METROPOLITAN GOVERNMENT OF NASHVILLE AND DAVIDSON COUNTY

STAFF RECOMMENDATION
1011 Petway Avenue
December 17, 2014

Application: New construction-addition
District: Greenwood Neighborhood Conservation Zoning Overlay
Council District: 06
Map and Parcel Number: 08301023100
Applicant: David Baird, Architect
Project Lead: Allison Asbrock, robin.zeigler@nashville.gov

<p>Description of Project: The application is for the reconstruction of a non-historic rear addition and the new construction of a rear addition.</p> <p>Recommendation Summary: Staff recommends approval with the conditions that:</p> <ul style="list-style-type: none"> • Staff approve the final details, dimensions and materials of the windows and doors prior to purchase and installation; • Staff approve the roof color and masonry color, dimensions, and texture; and, • The HVAC unit be located behind the house or on either side beyond the mid-point of the house <p>With these conditions, Staff finds that the proposed addition meets II.B.1 and II.B.2 for new construction of an addition for the Greenwood Neighborhood Conservation Zoning Overlay</p>	<p>Attachments A: Photographs B: Site Plan C: Elevations</p>
---	---

Figure 2: 1957 Sanborn Map of 1011 Petway

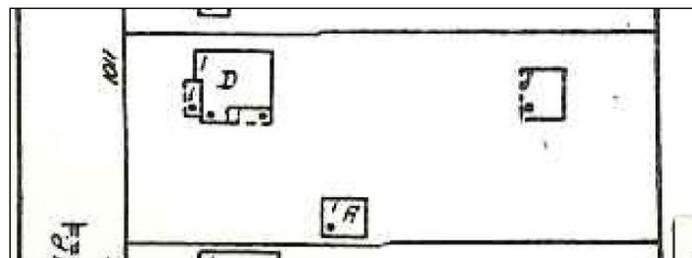
Background: The property located at 1011 Petway Avenue is a one and a half story transitional Victorian residence constructed approximately 1930. The side porch was enclosed and a rear addition was added to the structure after 1957, as the Sanborn Map of that year indicates the original form of the home was still intact (Figure 2).

① SOUTH ELEVATION
 1/8" = 1'-0"
 0 2' 4' 8'

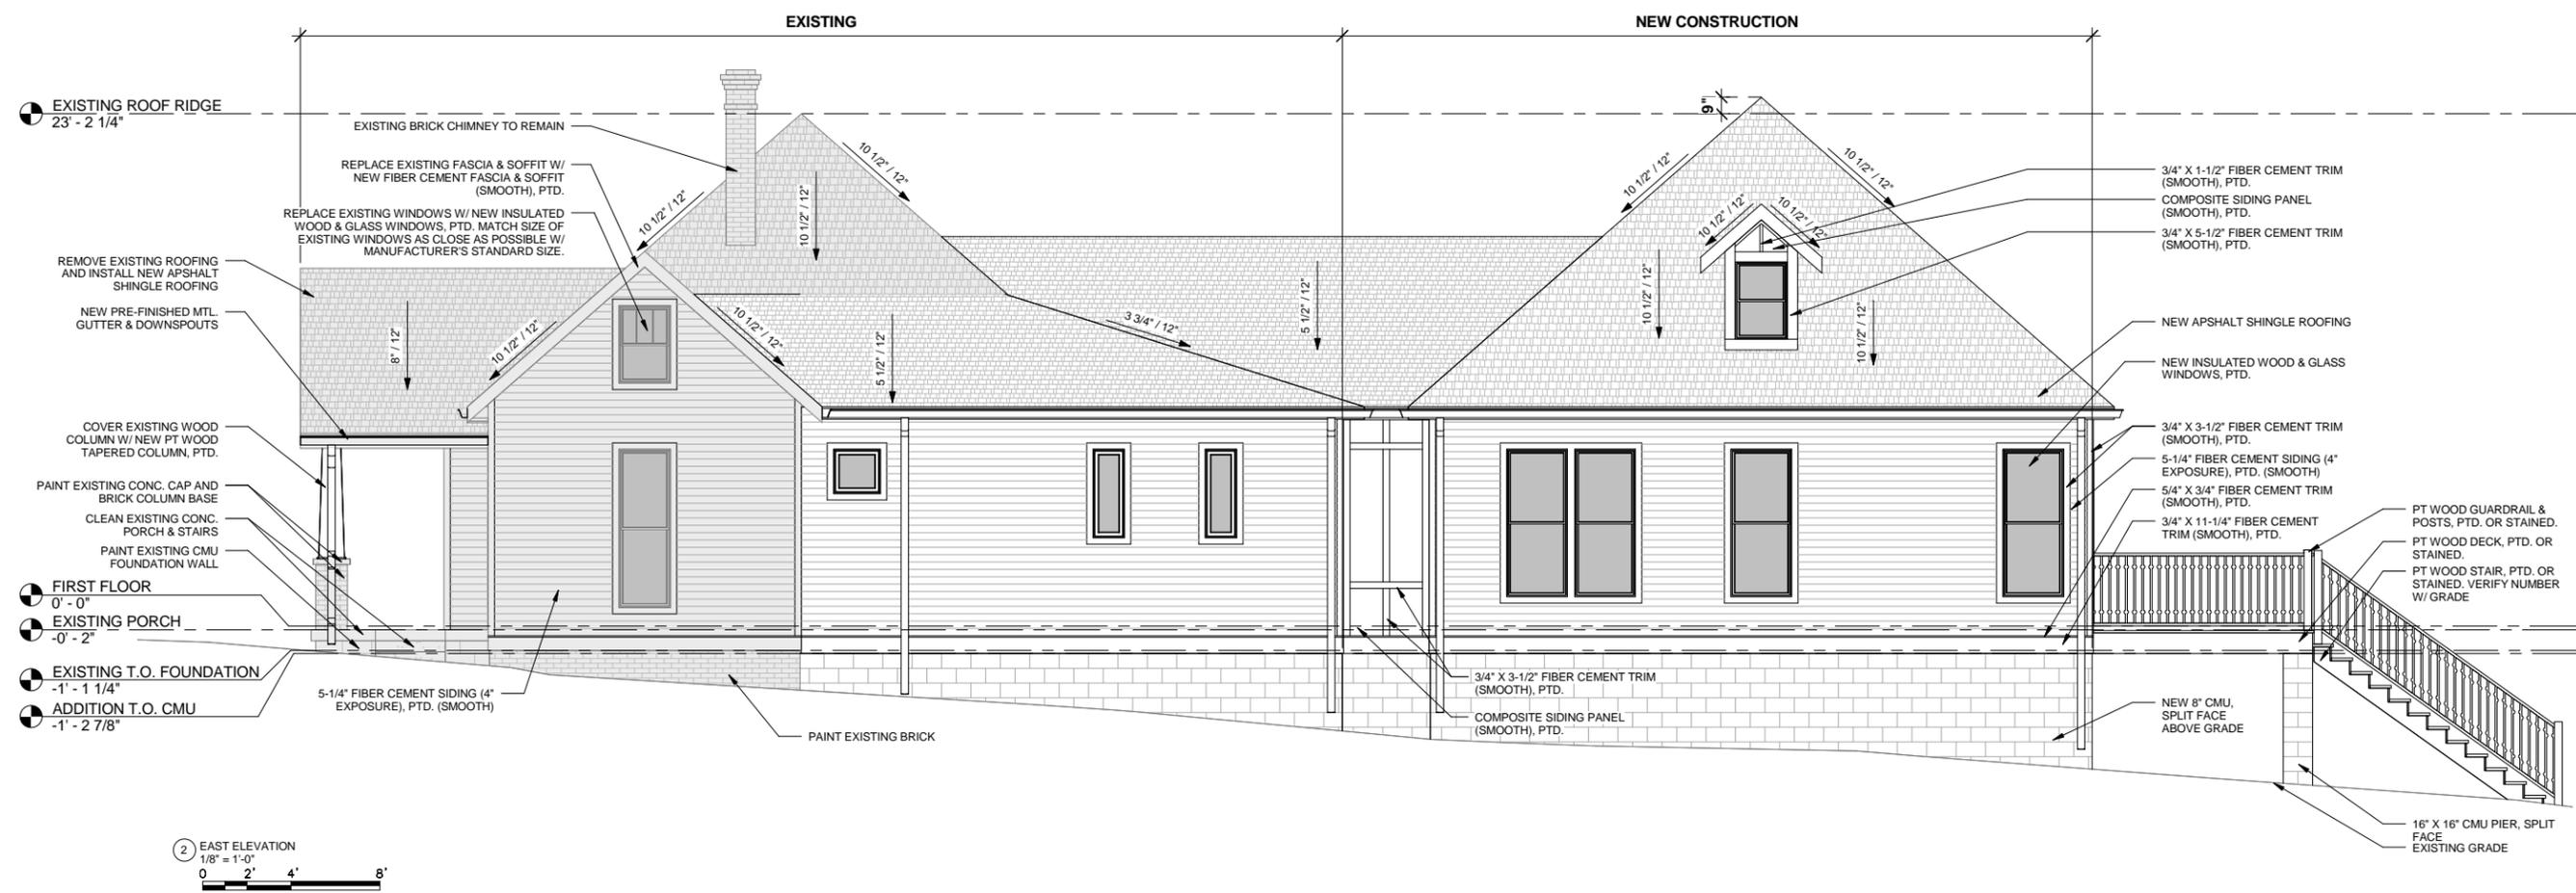
The existing structure is a one and a half story home with a one story non-historic addition at the rear of the property. The non-historic addition will be reconstructed at one story, with a full one and half story addition on the rear. The width of the new addition at thirty-three feet and seven inches (33' 7") matches the width of the original non-historic addition which is one foot six inches (1' 6") less than the width of the historic structure. The addition's foundation height will match that of the existing house.

The proposed addition will maintain the eave height of the existing house at approximately ten feet (10') from the foundation. The ridge height of the existing home is approximately twenty-three feet two and one quarter inches (23' 2 1/4") from the foundation. The maximum ridge height of the addition is approximately nine inches (9") taller than the existing structure ridge, giving the addition a total height of twenty-three feet eleven and one-quarter inches (23' 11 1/4") from the foundation. Staff finds this additional height to be appropriate since it does not take place until approximately sixty feet (60') feet from the front wall of the house, is a minimal amount and because the only portions of the addition visible from the street will be roofing and a section of a dormer. The design guidelines allow for as much as four-feet in additional height once the addition is approximately forty-feet (40') back from the front of the building. Not maxing out this option, as proposed, is preferable because pyramidal central roof form will make so much of the addition's roof form visible.

The roof of the addition is a hipped roof and ties into the existing structure with a gable roof connector. This side gable roof ties into the original roof nine feet (9') from the existing ridge which meets the guidelines. The pitches of the hipped addition match the pitches of the historic house at 10.5/12. The pitch of the gable roof connector is 5.5/12. Staff finds both the hipped roof and gable connector roof forms to be compatible with the existing pyramidal and cross gable roof forms of the historic house.

Three gable roof dormers are proposed for this project. One dormer on each side façade is proposed for the addition. The third dormer is located on the left/west façade within the original roof surface of the historic structure. All three dormers are gable dormers with 10.5/12 pitches that match the roof form. The location and size of the dormers meet all
